Informal document GRVA-18-17*
18th GRVA, 22 Jan -26 Jan 2024,
Provisional agenda item 6(b)

Proposal for amendments to UN-R79 to provisions on Full Power Steering

Submitted by the experts from CLEPA and OICA

R79 Amendments to Steer-by-Wire*

Motivation for new alternative 5.3.3.6.

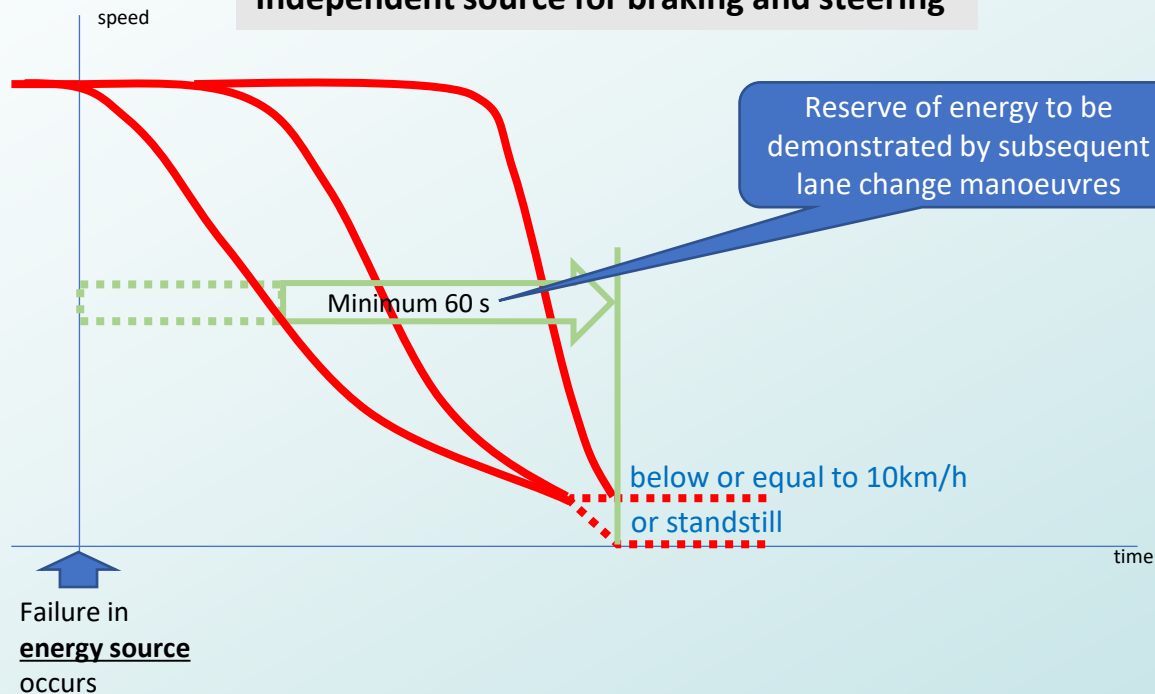
- Current Steer-by-wire requirements (5.3.3.3.) specify that 25 figures of 8 must be feasible upon a **failure of the energy source**
- “25 figures of 8” is almost 40 minutes of successive curves at 10km/h, representing energy for hundreds of kilometers on a motorway
- This represents a huge amount of energy to be secured to supply steering and also other systems
- Modern technologies for energy and power circuit management systems ensure a reliable monitoring of available energy
- The intention of the proposal is to guarantee the vehicle will automatically come to a safe state ($\leq 10\text{km/h}$ or standstill) before all the energy is “burnt” and in turn optimizing (reducing) the amount of energy to be secured in case of a **failure of the source**

Explanation of alternative concept

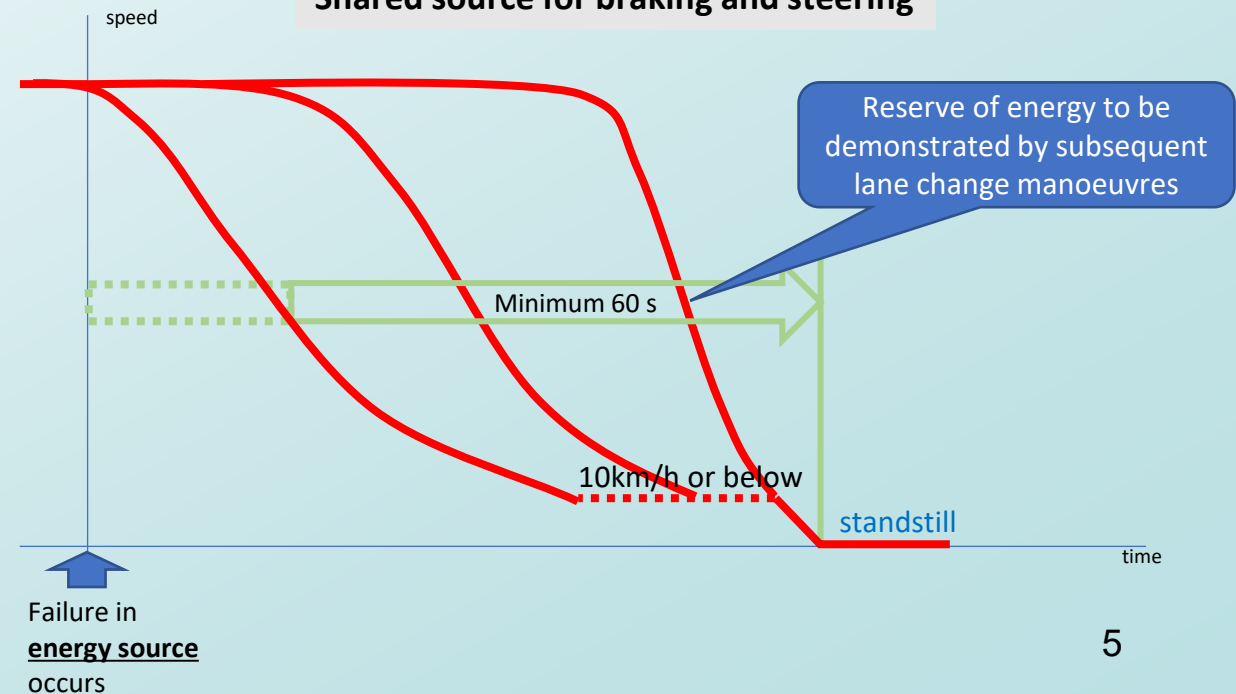
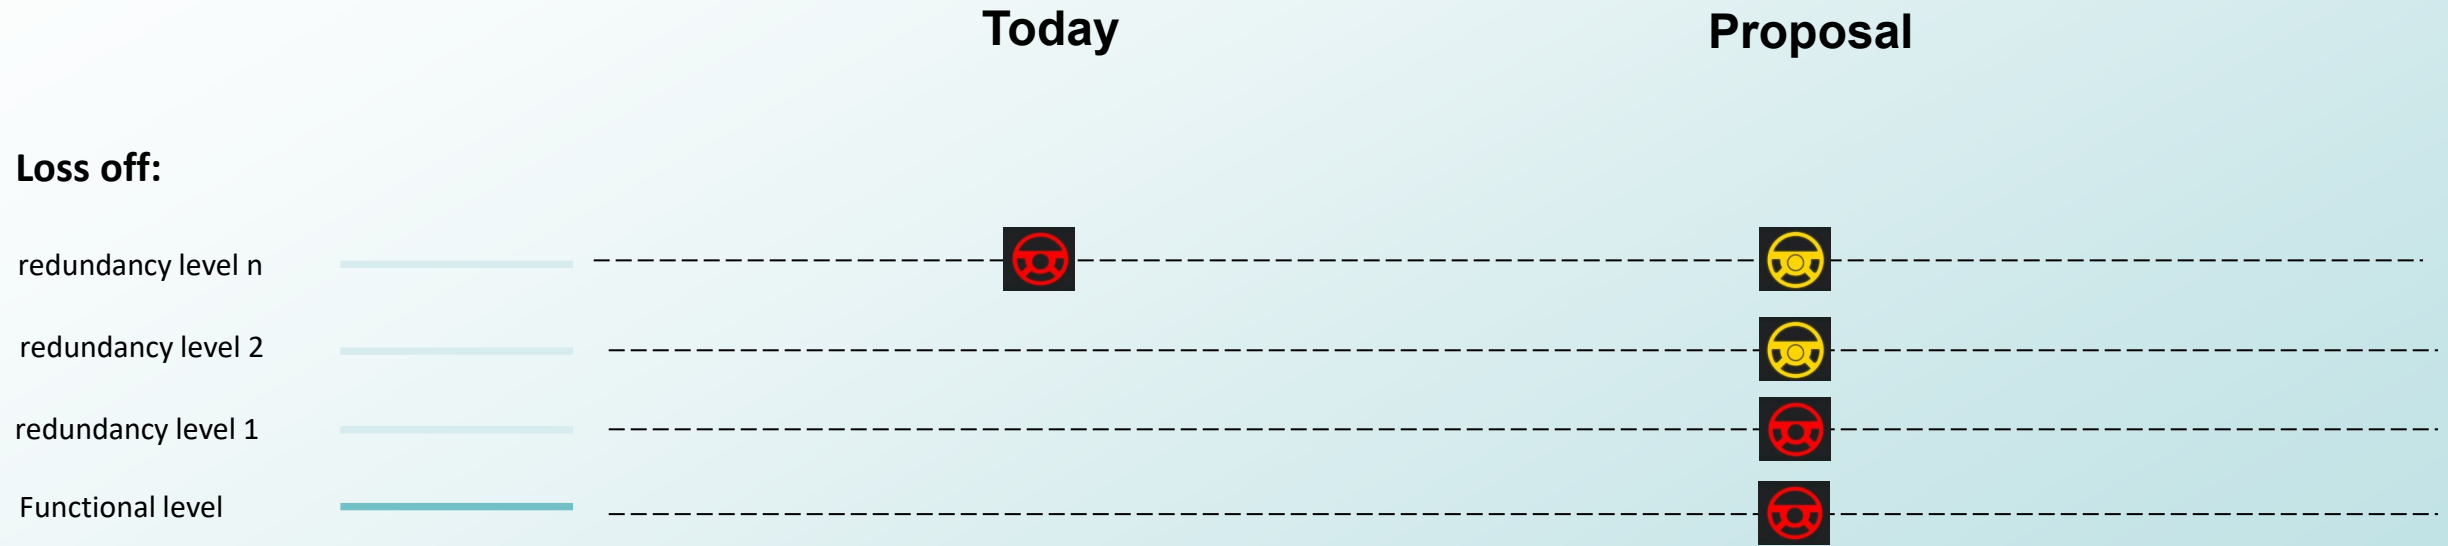
Alternative approach

Independent source for braking and steering

Shared source for braking and steering

5.3.3. Full power steering systems
5.3.3.3. In the event of a failure of the energy source of the control transmission, it shall be possible to carry out at least 24 "figure of eight" manoeuvres, where each loop of the figure is 40 m diameter at 10 km/h speed and at the performance level given for an intact system in paragraph 6.
The test manoeuvres shall begin at an energy storage level given in paragraph 5.3.3.5.
